March 15, 2019

NOTICE OF ADDENDUM ADDENDUM NO. 3

CONTRACT NO. 7528, PROJECT NO. 10305 NAKOOSA TRAIL FLEET/FIRE/RADIO SHOP FACILITY

AS-002

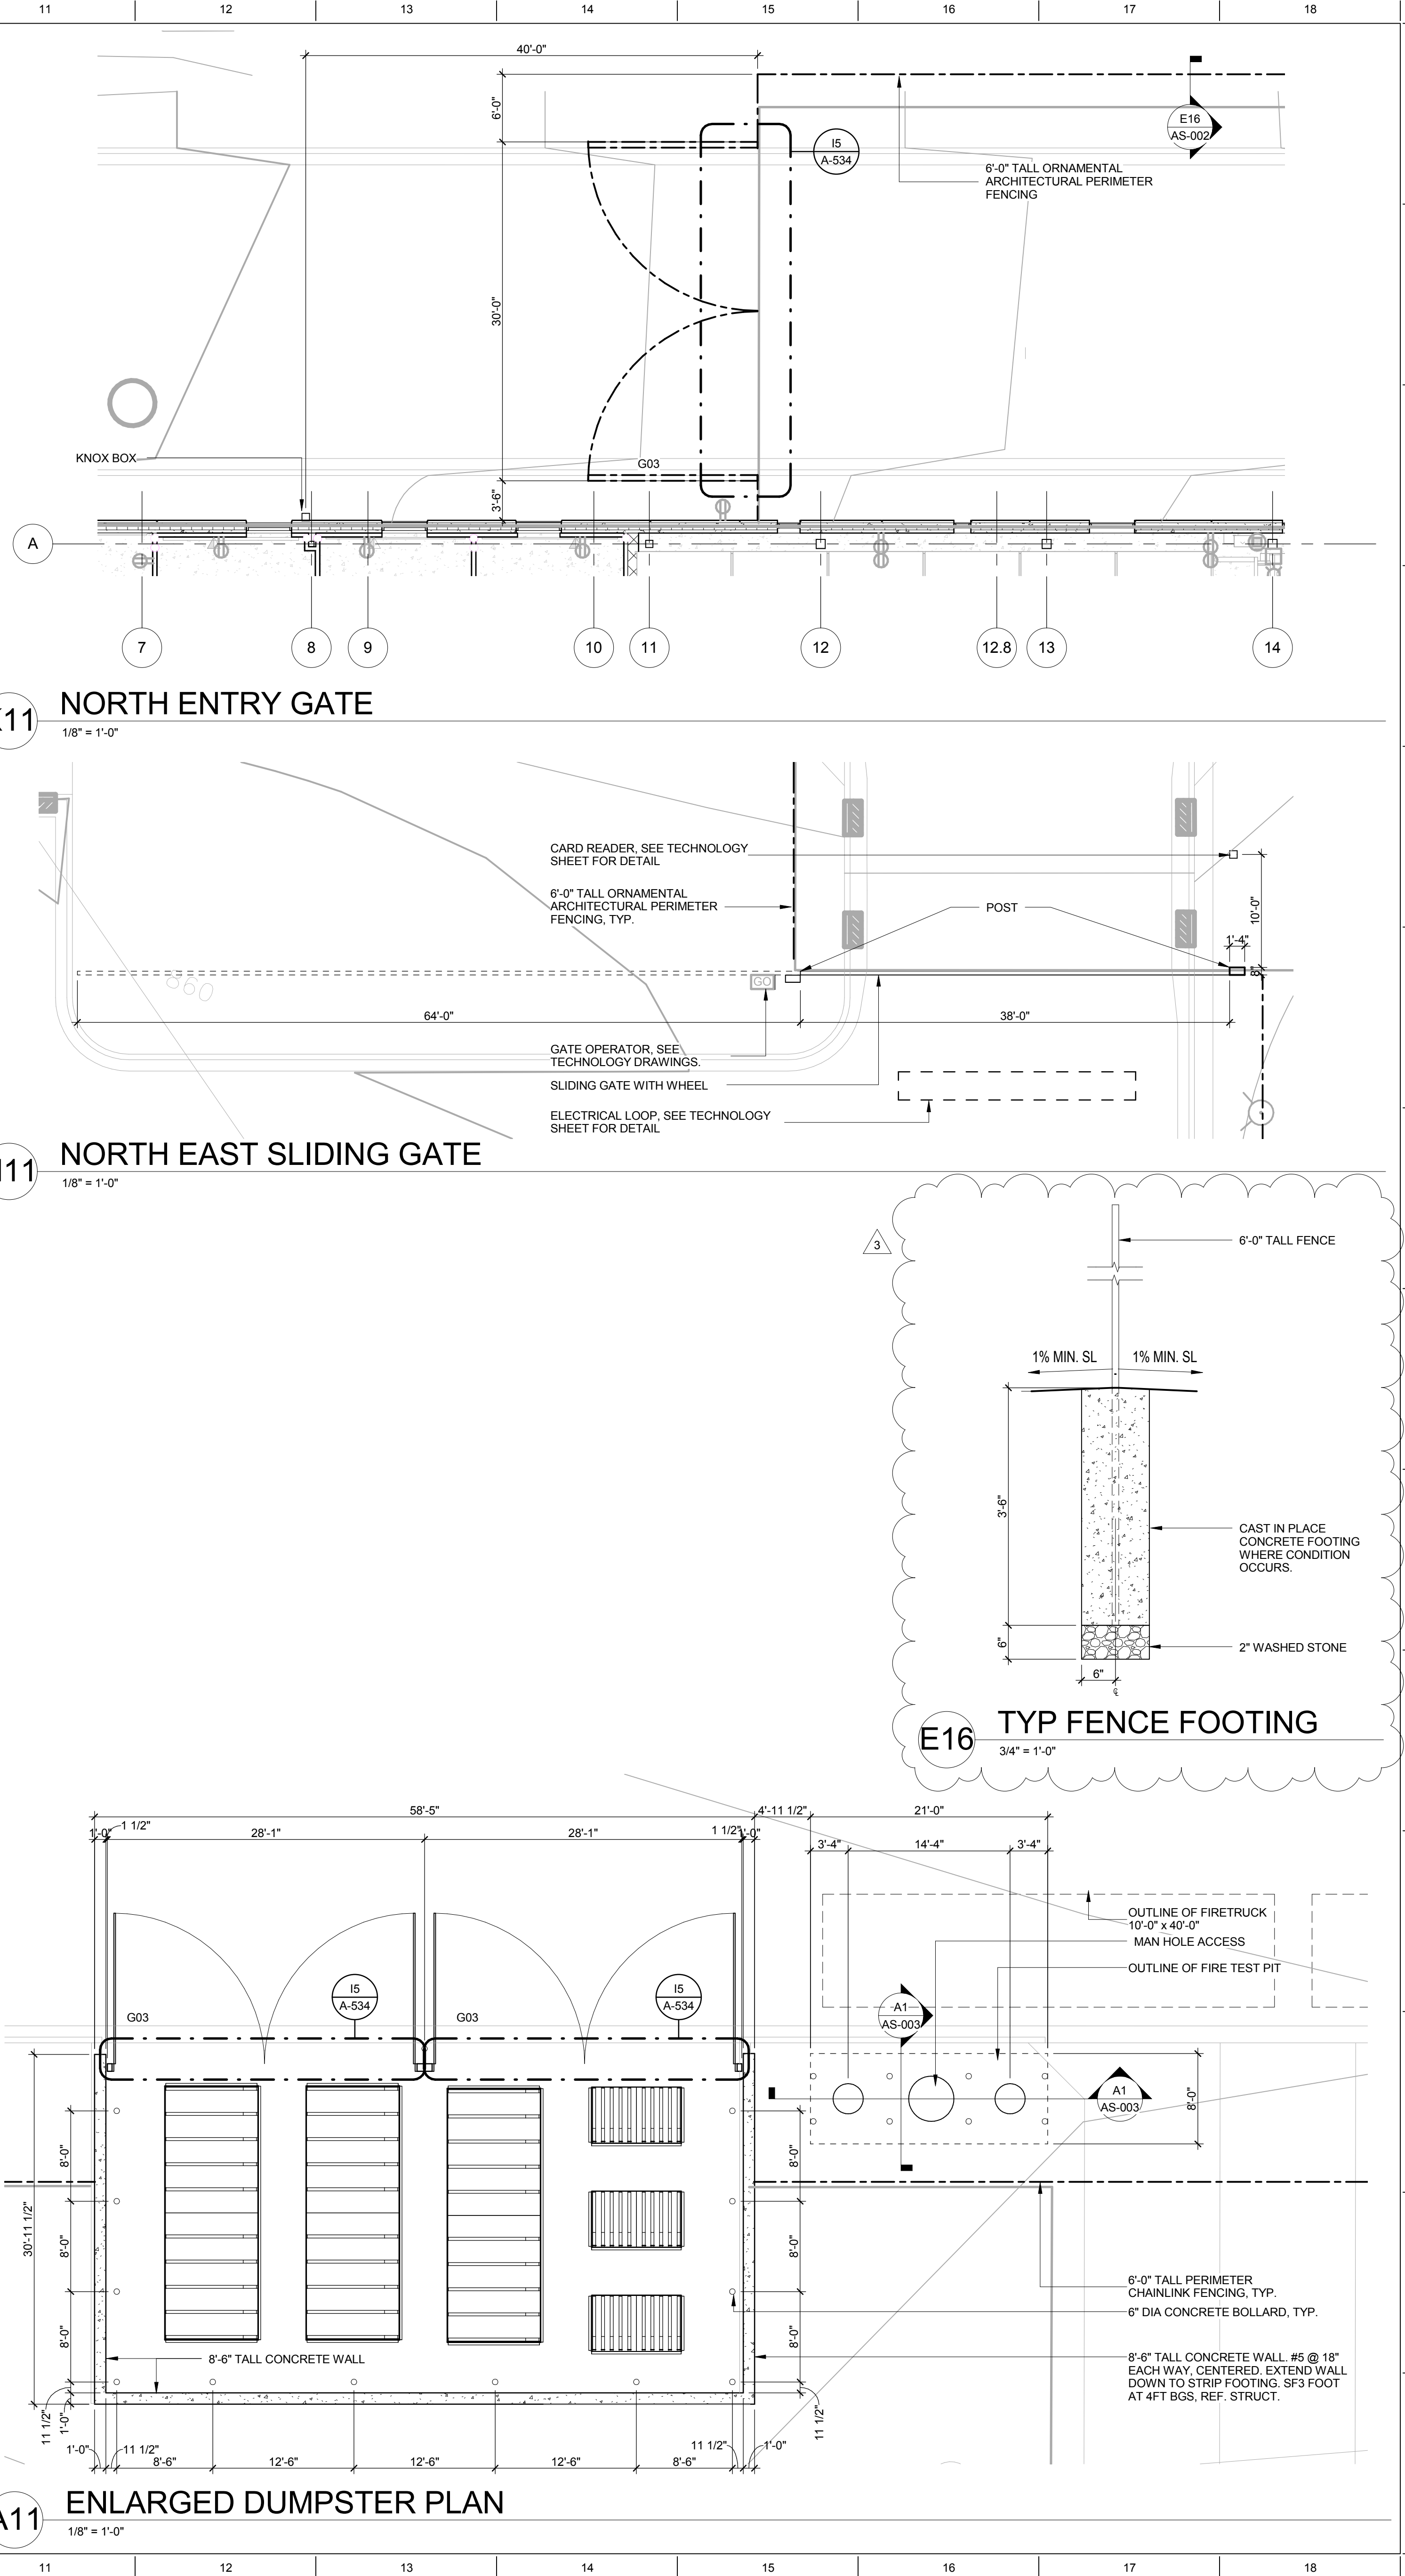
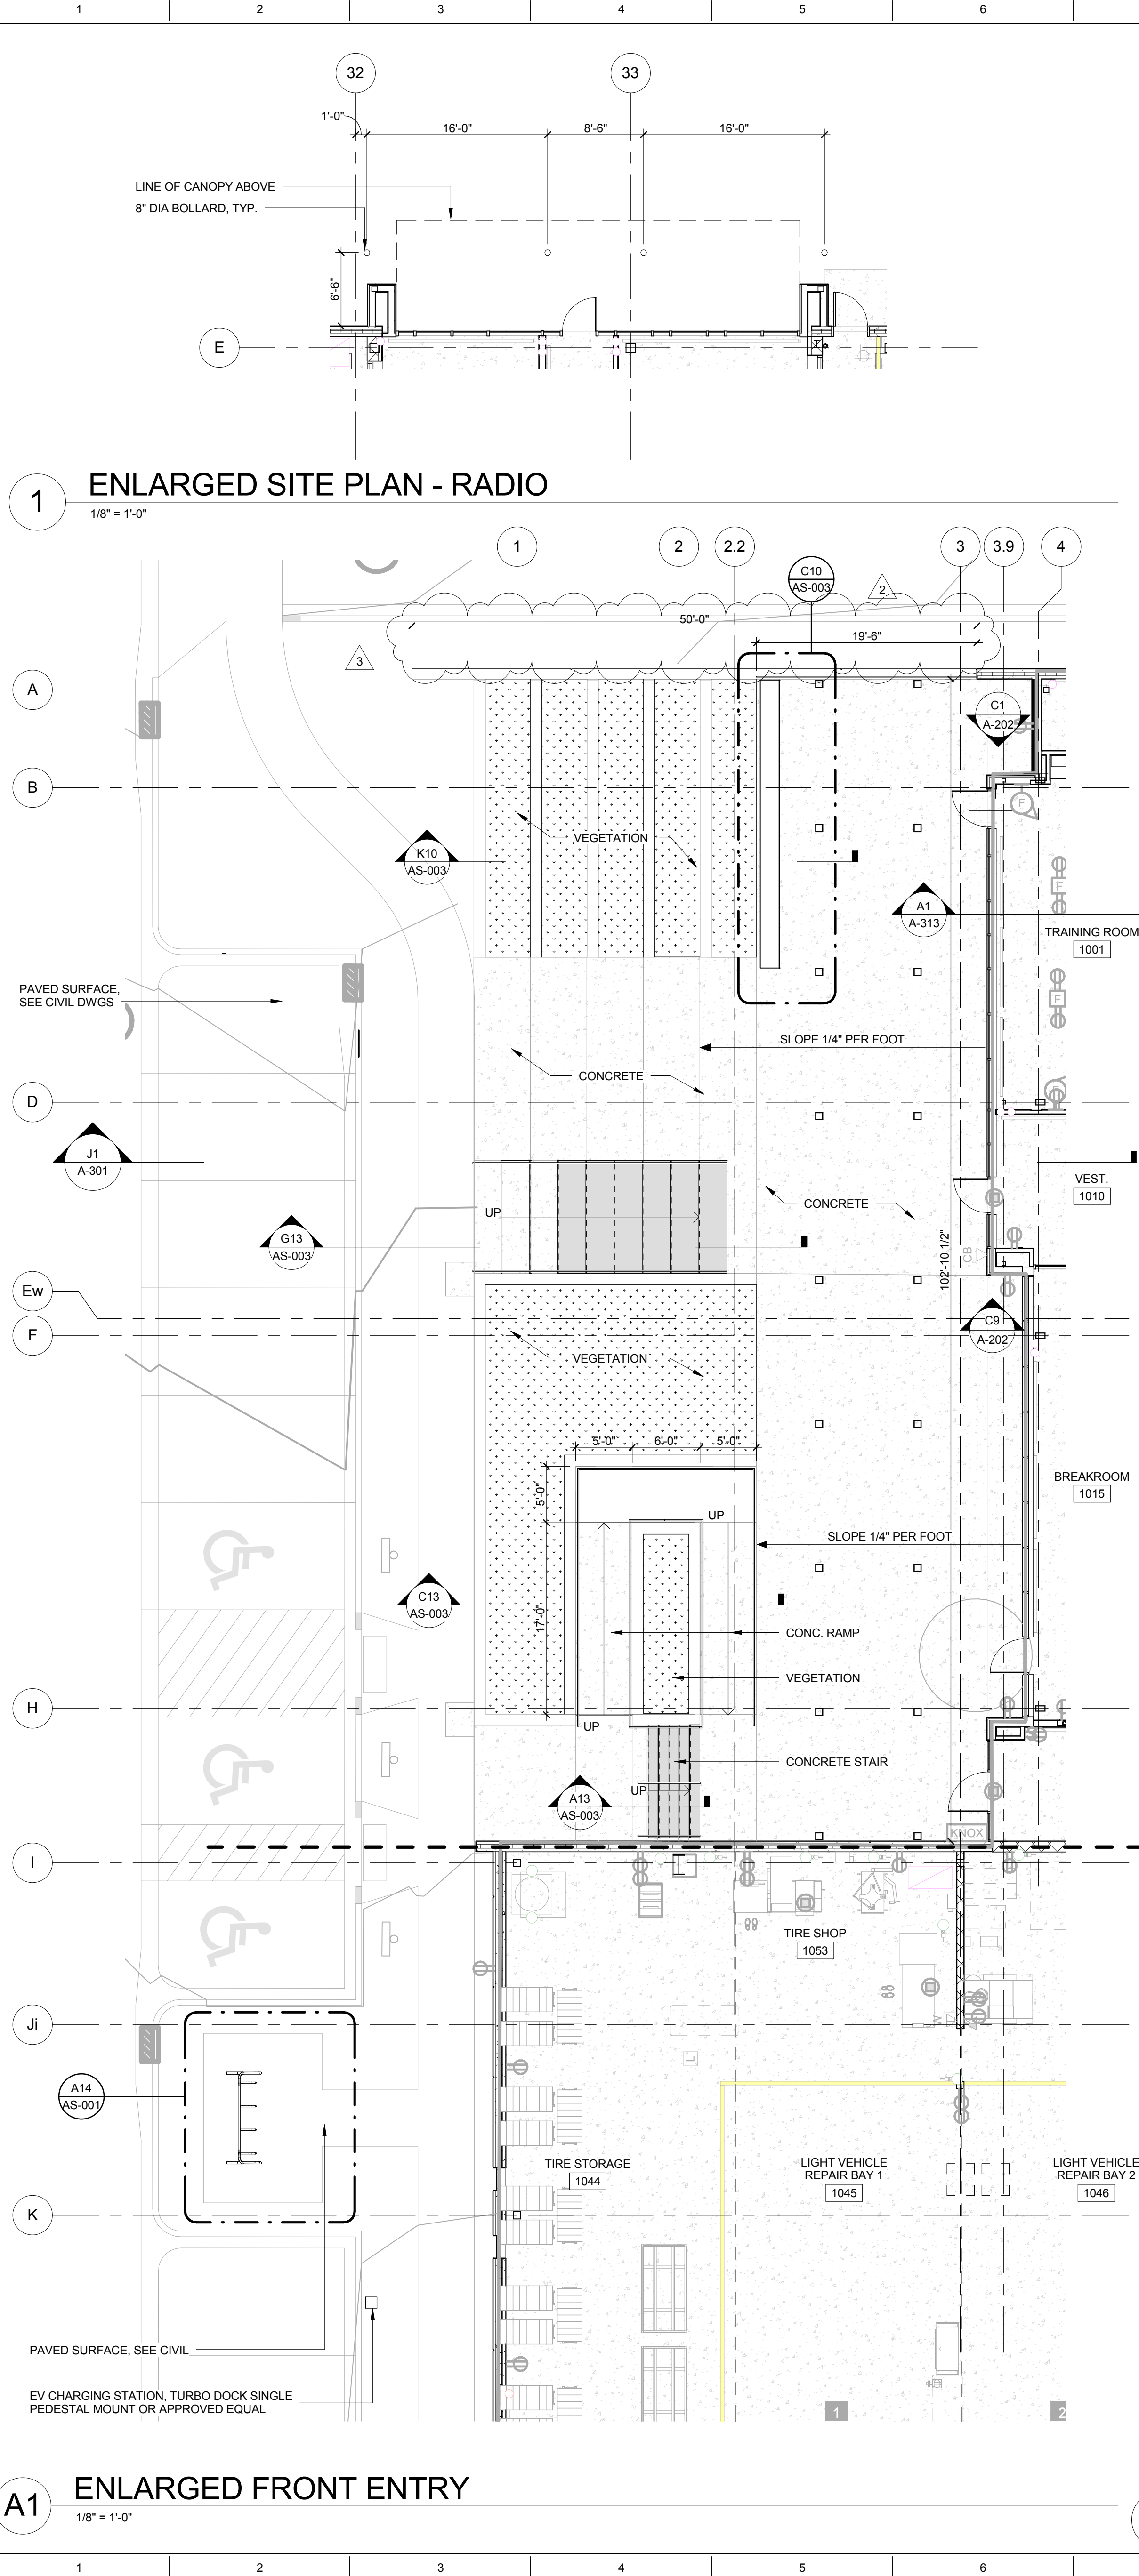
- M. **MODIFIED** AS-002-ENLARGED SITE PLAN to include E16 Typical Fence Footing detail and add an overall length dimension in detail A1.
- N. **MODIFIED** AS-003-SITE SECTIONS to remove an exterior bench detail, remove note 3 in detail A1, and add a hatch pattern and material callout to detail K10.

A-106

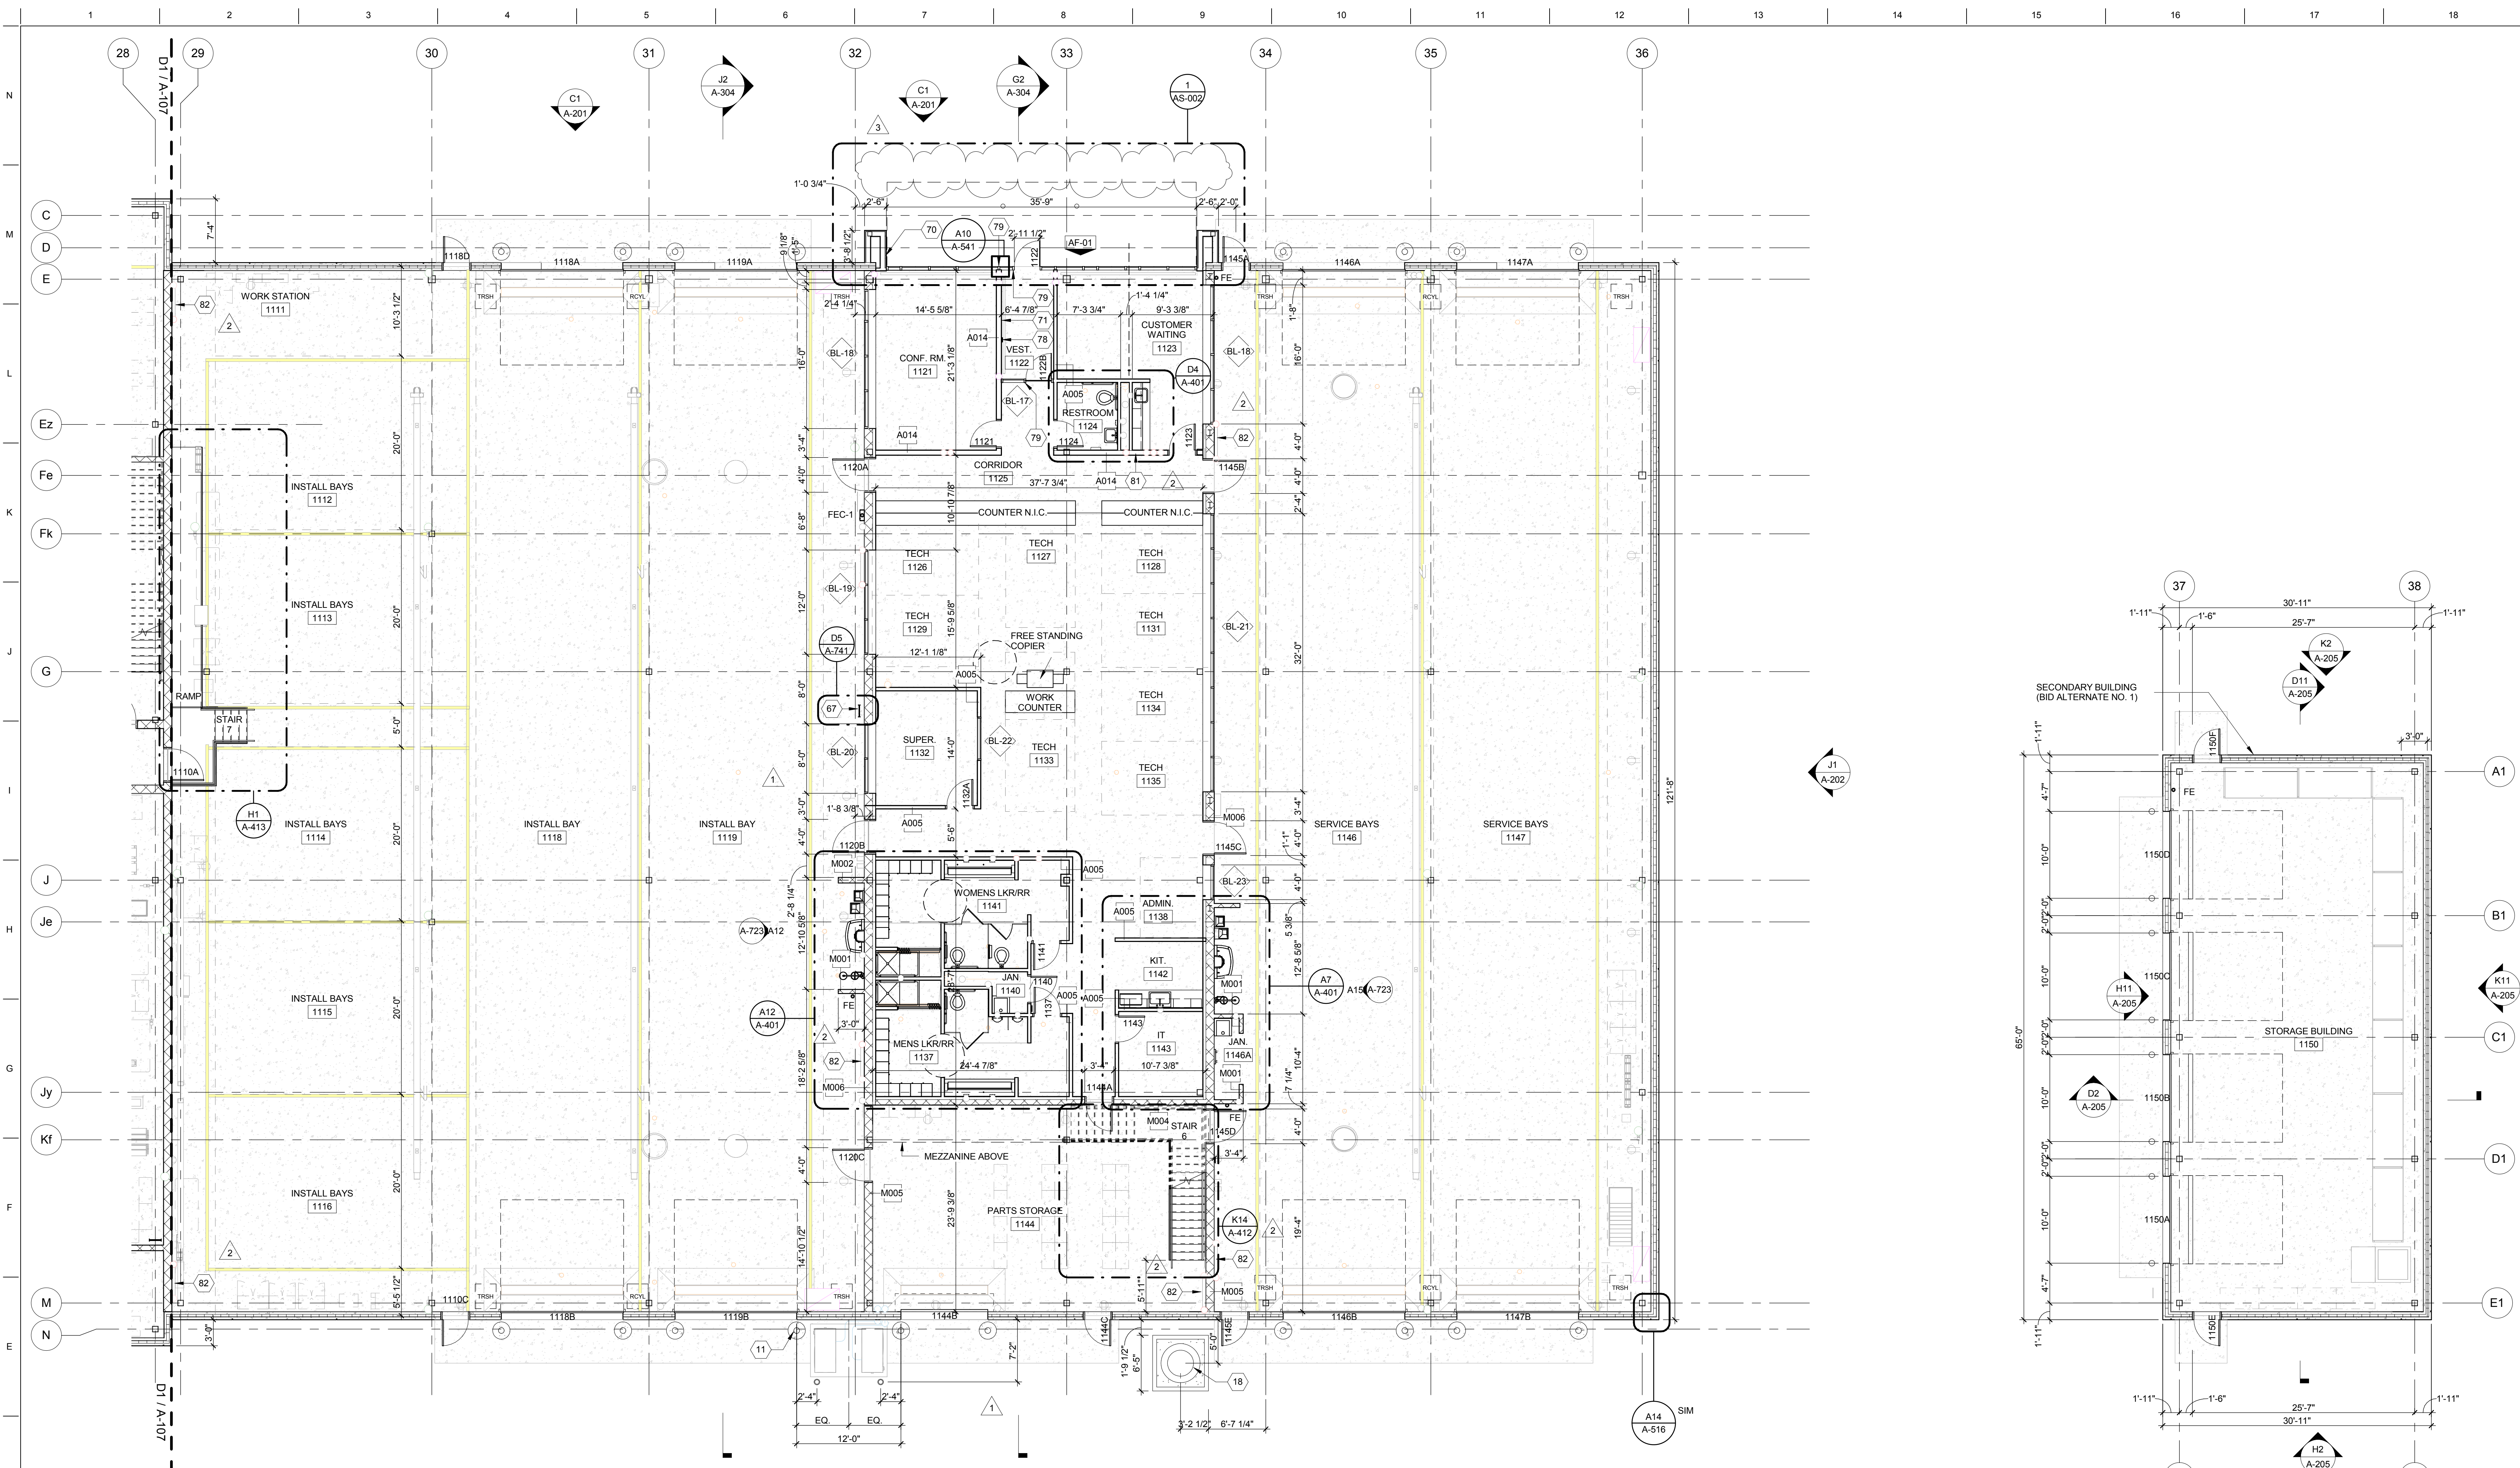
Q43: Spec. 07 95 13.13, Sheet A-106 & S-131C – Spec section 07 95 13.13 calls for Interior Expansion Joint Assemblies. Can we get clarification on A-106 & S-131C or others where they should be accounted for and whether there's a concrete floor detail that should be followed to receive the assemblies along Grid Line 17? Will a Wall to Floor assembly be required?
